Re: BRM-00255020-A0 Hydrogeological Review - Bacher Construction Ltd. - Pit and Quarry  
Township of Algonquin Highlands, Haliburton County, Ontario

We are pleased to present this preliminary hydrogeological review regarding the Application for Site Plan Approval submitted by John Bacher Construction Ltd. to the Ministry of Natural Resources and Forestry (MNRF). The development of a pit and a quarry are proposed on the discussed site, which is in the Township of Algonquin Highlands (former McClintock Twp.), Haliburton County, Ontario.

Figure B. Groundwater Contour Map

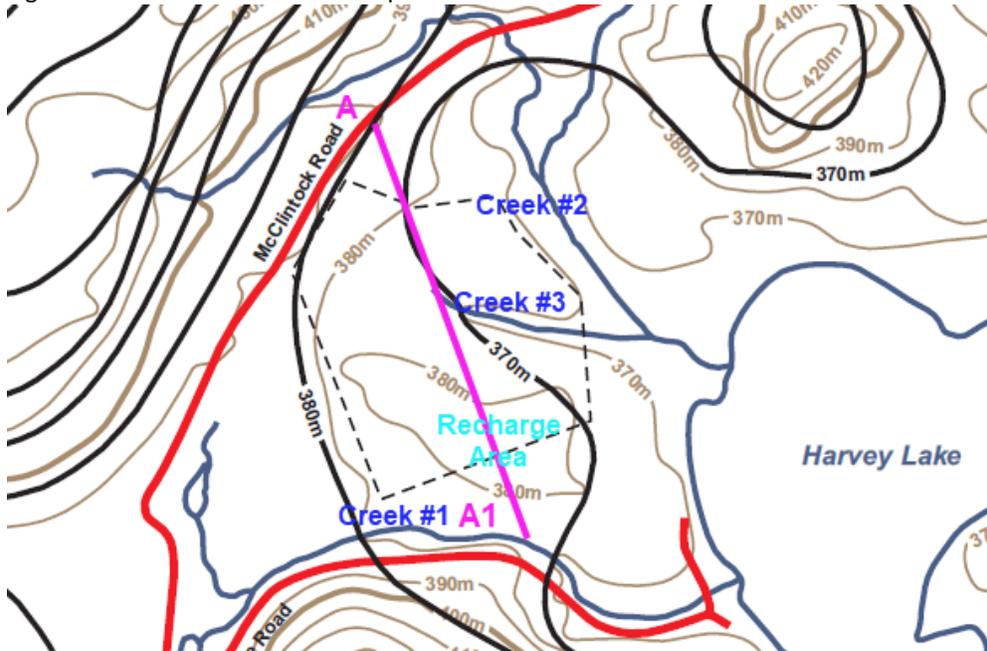
A groundwater contour map for the site was presented on Figure 4 by Waters Environmental Geoscience Ltd. (2016), hereinafter referred to as Waters. A detail of Figure 4 is shown on the appended Figure B.

On Figure 4 of the statement, water levels are sketchily presented with 10 m interval contours, which according to Waters are interpreted to represent the highest groundwater conditions onsite. So far, the site lacks field evidence to characterize it properly, as there are no onsite monitoring wells. To EXP's knowledge, groundwater levels were not measured onsite by Waters and no monitoring program of water levels has been implemented, and no well water well records are reported within 1 km of the study area. Therefore, the claim that Figure 4 of the Waters report is representative of highest groundwater levels cannot be supported. To provide such information, onsite monitoring wells are required, and multi-year seasonal groundwater level monitoring is needed.

For that reason, EXP disagrees with the stated interpretation (representation of highest groundwater conditions), as seasonal groundwater fluctuations and especially high-water levels during spring thaw (freshet) are yet unknown. The document by Waters (2016) rightly claims to be a "Groundwater Summary Statement", which is not a detailed hydrogeological report.

The groundwater contours shown on Figure B suggest discharging conditions to creeks #1 (south) and #3 (center) and recharging conditions between these streams. The assumed horizontal water table in cross-section A-A1 of the final Site Plan by Timber Craft Consultation Inc. (2019), as depicted on Figure C, is inconsistent with the interpretation made by Waters (2016). Generally, under current recharge conditions, the groundwater surface would somewhat mirror the surface topography for low hydraulic conductivity soils/rocks, and it would flatten, if the hydraulic conductivities are high.

EXP, following the water levels interpretation made by Waters (2016), observes that the water table has relief (as depicted in Figure B) and accordingly, the proposed quarry floor is predicted to be below the water table, as shown on Figure D.

Figure C. Assumed Water Table in Cross-Section A-A1

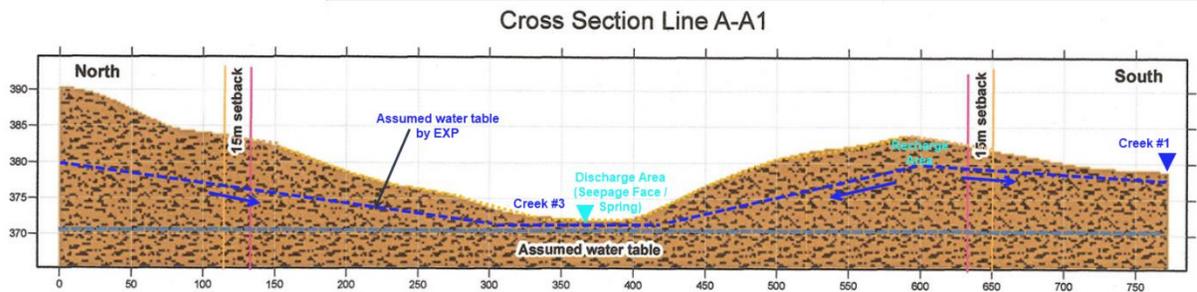
According to cross-section A-A1 presented on page # 2 of the Final Site Plan by Timber Craft Consultation Inc., there are no anticipated potential impacts shown on the horizontal water table. EXP's view on this prediction is that this seems a very unlikely and unrealistic scenario. EXP would expect an alteration of recharge areas and contribution to surface water features, potential effects on water quality (surface and groundwater), disruption of discharge areas and potential impacts on natural features, lowering of water table and changes in flow regime as likely outcomes of the extracting activity. Potential impacts due to the proposed pit/quarry development can be assessed with a detailed hydrogeological investigation.

Figure D Assumed Excavation below the Water Table in Cross-Section A-A1

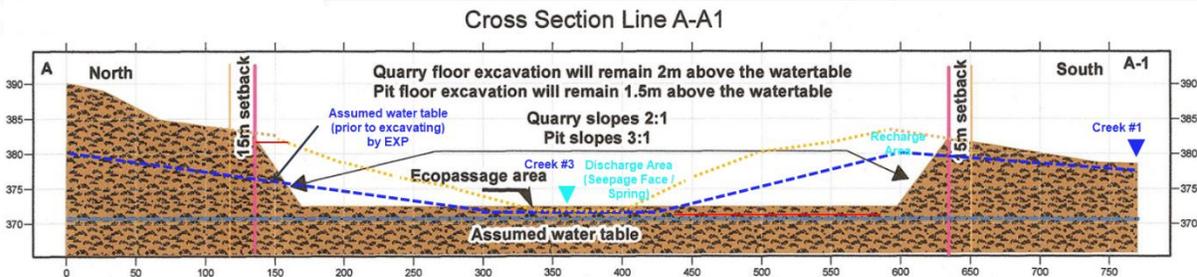
According to policy No. A.R.4.01.04, a minimum spacing of 2.0 m (and 1.5 m) needs to be maintained between the projected quarry (pit) floor and any static water level including seasonal high for bedrock (and overburden), respectively. Waters (2016) states that Bacher Construction Ltd. should avoid extracting bedrock below 382.0 masl in the northwest and 370.0 masl in the east. The elevation limit of 370.0 masl in the east is deemed as too low by EXP, based on surrounding elevation of surface water features, subject to actual field investigations.

EXP has the opinion that the proposed Site Plan by Timber Craft Consultation Inc. (2019) does not conform to the description "as above groundwater extraction of pit or quarry operation", and consequently, cannot be approved for a Category 9 or 11 application under the Aggregate Resources Act.
